**City of Bellevue
Development Services Department
Land Use Staff Report**

Proposal Name: Peterson Short Plat

File Number: 14-124731-LN

Department Decision: Approval with Conditions

Figure 1 – Preliminary Short Plat Proposal

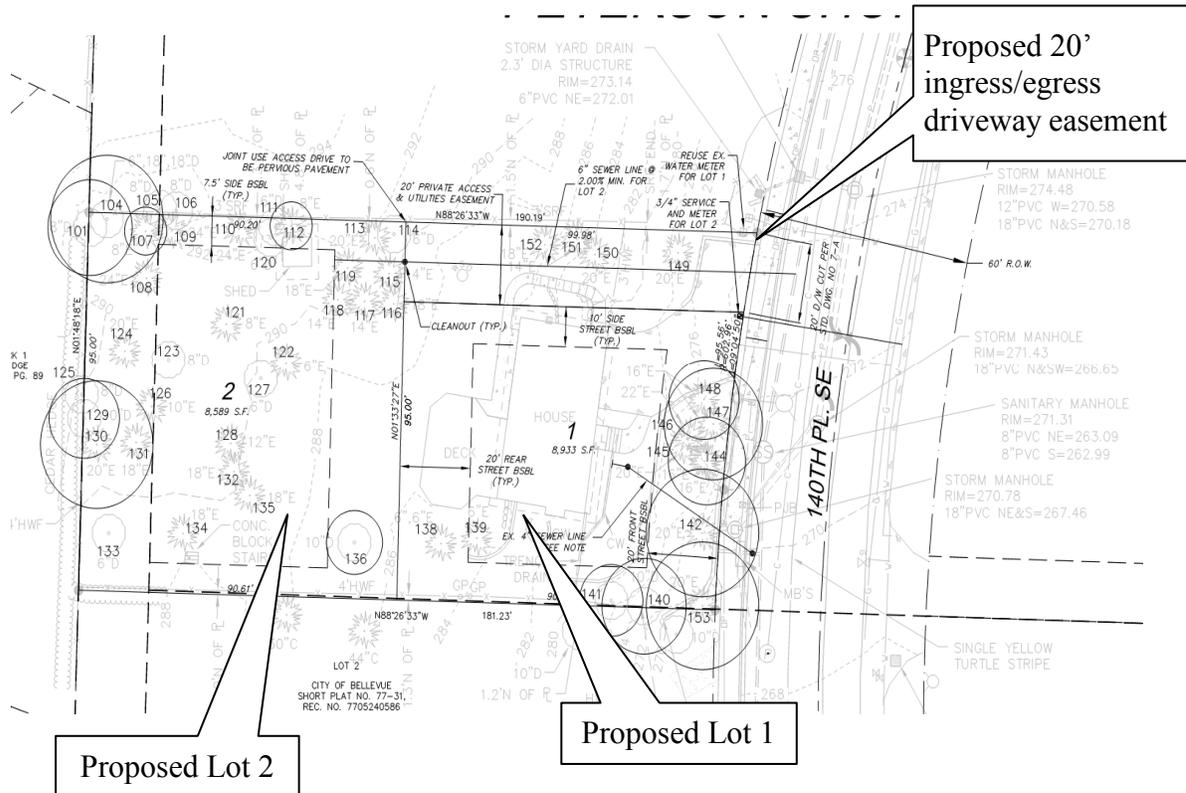
The applicant is proposing to short plat an existing 17,522 square foot lot (approximately 0.40 acres) into two single-family lots. The subject site is located within the R-5 land use district, and within the Southeast Bellevue subarea. The site contains an existing single-family dwelling which will be demolished as a result of this short plat proposal. Access to the two proposed lots will be from a proposed ingress/egress driveway easement, which will run along the northern side of each lot, and accessed off of 140th Place SE. Incorporation of the ingress/egress driveway easement will allow the existing curb cut off of 140th Place SE to be utilized.

As defined by Land Use Code 20.25H, the site does not contain any critical areas; however, the property currently contains 37 significant trees consisting of Horse Chestnut, Western Hemlock, Grand Fir, Giant Redwood, Pacific Dogwood, and Apple (670 diameter inches). The applicant proposes to retain 14 of these trees, or 206 diameter inches, which equates to approximately 30.75% of the total diameter inches of the significant trees on the site.

Access to Lots 1 and 2 will be from a joint-use driveway off of 140th PI SE as shown on the approved plans. No other access connection to city right-of-way is authorized. The existing driveway which serves the existing house must be removed. Street frontage improvements matching adjacent improvements must be provided at the location of the removed driveway.

The driveway width will be a minimum of sixteen feet with Fire Department Approval and must be built per the City's Transportation Department Design Manual Standard Drawing DEV-7B.

The final plat shall have a note stating that the "16 foot wide paved access road to Lot 2 shall be posted and marked "FIRE LANE-NO PARKING" on both sides".

The final short plat map must include a note that specifies that the owners of lots served by the joint use driveway are jointly responsible for maintenance and repair of the joint use driveway. Also, the final short plat map must include a note that specifies that the joint use driveway will remain open at all times for emergency and public service vehicles and shall not be gated or obstructed.

The City of Bellevue urges the applicant to save as many trees as possible. The final short plat shall portray a minimum of 211 diameter inches of existing significant trees to remain, as proposed. A Tree Preservation Plan that portrays the drip-line, the diameter size, and common name of each significant tree to be retained must be recorded with the *final short plat mylar* (recorded with King County). This Tree Preservation Plan must also contain the following note:
